OB-005-2015

Application for "Other Business"
Cobb County, Georgia

Re: Request to Amend Zoning Stipulations for Impervious Surface Calculation at 3711/3731 Robinson Road (Z-44; BOC approved 8/20/13) AKA Alderwood Subdivision

HOUSE LOCATION PLAN OF:
LOT 4
ROBINSON ROAD
LAND LOT 967, 16th DIST. 2nd SECT.
COBB COUNTY, GEORGIA
SCALE: 1"=30'
PROJECT NO: 13004
PLAN PREP: 12.22.14
MADE FOR: CENTURY PARTNERS, LLC

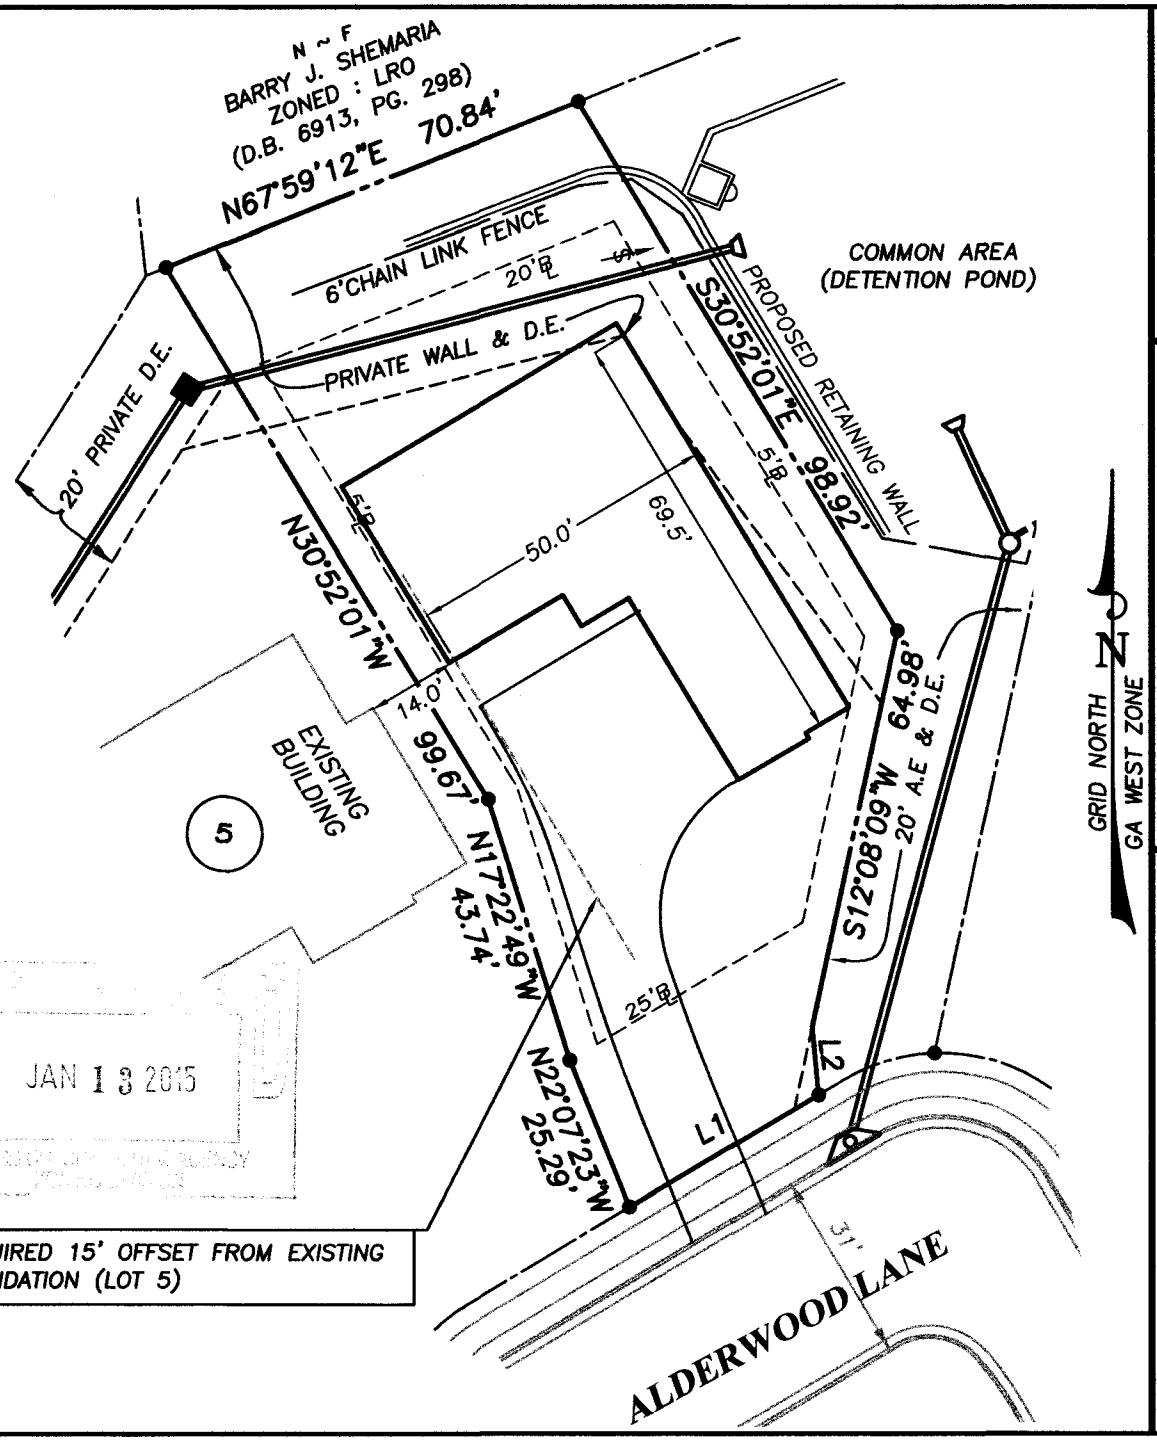
On my remaining 3 lots, which border the O&I and LRO zoned properties and my detention pond, I need a little bit of help with my maximum allowable impervious surface area on lots 2, 3, and 4 which is currently 40%. I am hereby requesting that my zoning stipulations be amended to add a condition that would allow for up to a maximum of 47% impervious surface on lots 2 and 3, and up to 42% impervious surface on lot 4.

The mitigating factors to support this increase in impervious surface on lots 2, 3, and 4 may be recognized through the abundance of excess and unused pervious surface in the landscape island and the adjoining strip of land, that I was forced to acquire in order to obtain sewer access. Both of which will be deed restricted from development and owned as common area by the HOA. This will provide for 6,378 SF of deed restricted, landscaped pervious area which is far in excess of the additional 1,470 SF of impervious area that I am requesting to be allowed on lots 2, 3 and 4. Additionally, there is current excess of unused impervious surface area on lots 1, 5, 6, 7, and 8 which totals 3,375 SF of landscaped, pervious area. Please see supporting calculations, survey, and final plat attached.

IMPERVIOUS AREA: 4,222 SQ FT
% IMPERVIOUS OF LOT: 40.9%
